FALLING COLORS

206 McKenzie St. Santa Fe, NM 87501

PROJ/JOB: True North Builders / 206 McKenzie St - ULTIMATE Prelim v1  
 DIST/DEALER: REULE SUN CORPORATION  
 DRAWN: DAVE WHELCHER  
 QUOTE#: A1G1X1X

**104B - (F) KITCHEN**

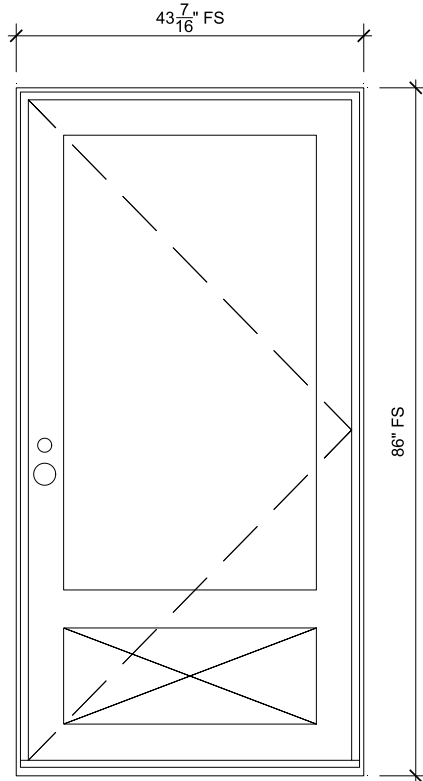
MarvinInswingFrenchG2 (A1) - MAKE BOTTOM FLAT PANEL PER DRAWING IN NOTES & ATTACHMENTS

DividedLite (A1) - NEED THIS DOOR AS OUTSWING?

Hardware (A1) - NOT YET PRICED FOR HARDWARE PREP, RMH. HARDWARE BY OTHERS

## 106A - (F) KITCHEN

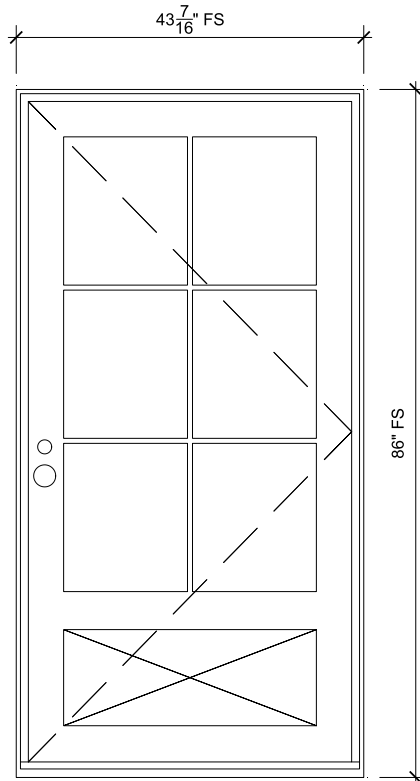
MarvinInswingFrenchG2 (A1) - MAKE BOTTOM FLAT PANEL PER DRAWING IN NOTES & ATTACHMENTS

Hardware (A1) - NOT YET PRICED FOR HARDWARE PREP, RMH. HARDWARE BY OTHERS

**119 - OFFICE**  
SCALE: 1/2" = 1'-0"

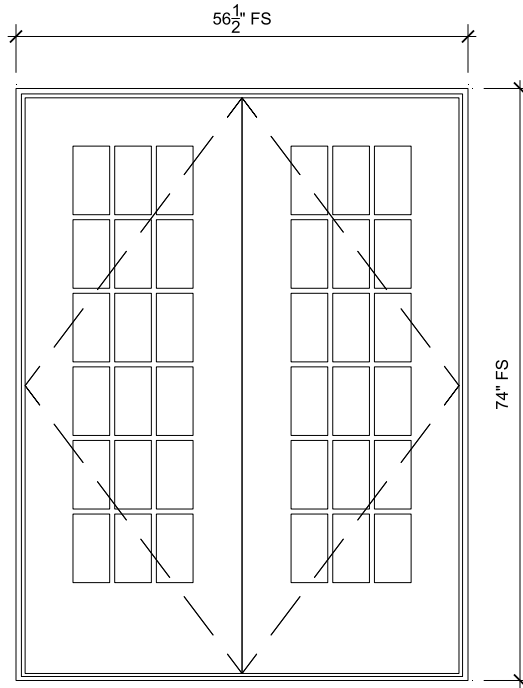
MarvinCD (A1) - MAKE BOTTOM PANEL PER DRAWING IN NOTES & ATTACHMENTS

Hardware (A1) - PREP FOR SPECIFIED HARDWARE NOT ADDED OR INCLUDED IN THIS PRICING.

## 124-OFFICE (SIZE ADJ!!!)

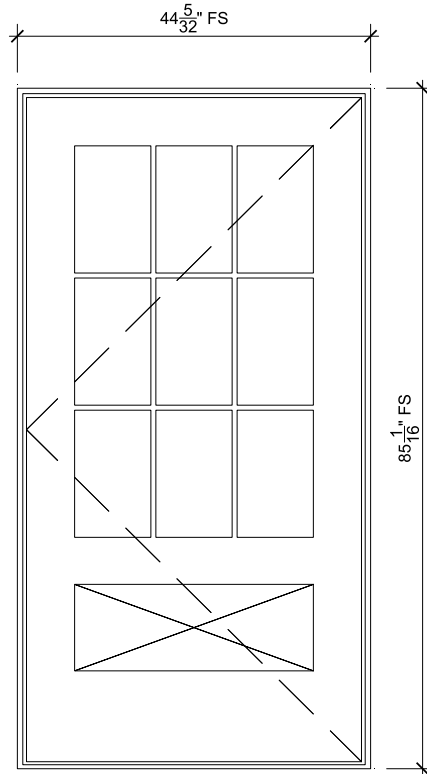
MarvinCD (A1) - MAKE BOTTOM PANEL PER DRAWING IN NOTES & ATTACHMENTS

Hardware (A1) - PREP FOR SPECIFIED HARDWARE NOT ADDED OR INCLUDED IN THIS PRICING.

## 130B-BREAKOUT(ACCESS CNTRL)

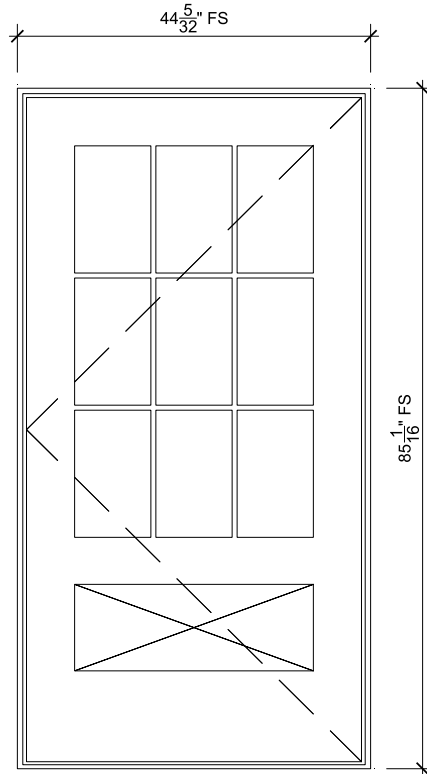
MarvinCD (A1) - MAKE BOTTOM PANEL PER DRAWING IN NOTES & ATTACHMENTS

Hardware (A1) - PREP FOR SPECIFIED HARDWARE NOT ADDED OR INCLUDED IN THIS PRICING.

**\* 131 - ENTRY (ACCESS CONTROL)**

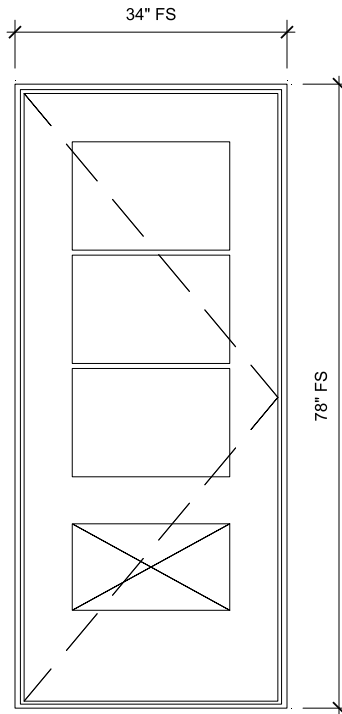
\* The quote for this unit has an error on it. Please verify availability prior to order.

## 135B - HALL (ACCESS CONTROL)

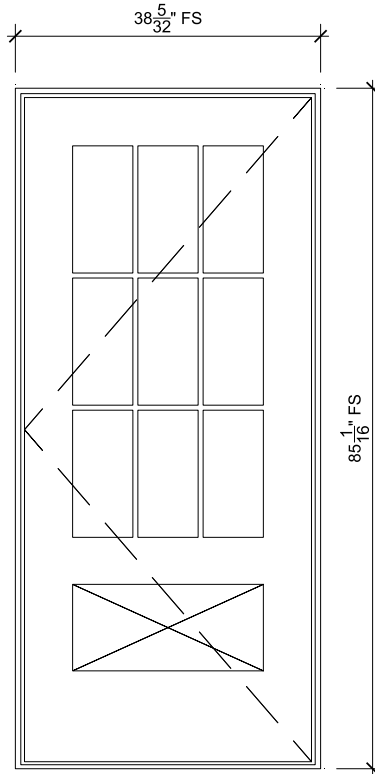
MarvinCD (A1) - MAKE BOTTOM PANEL PER DRAWING IN NOTES & ATTACHMENTS

Hardware (A1) - PREP FOR SPECIFIED HARDWARE NOT ADDED OR INCLUDED IN THIS PRICING.

**\* 211 - CONF (ACCESS CONTROL?)**

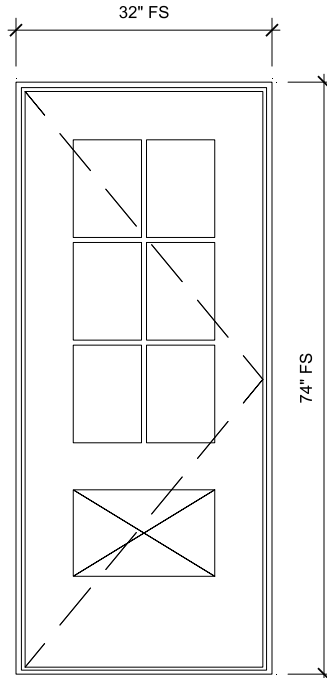
\* The quote for this unit has an error on it. Please verify availability prior to order.
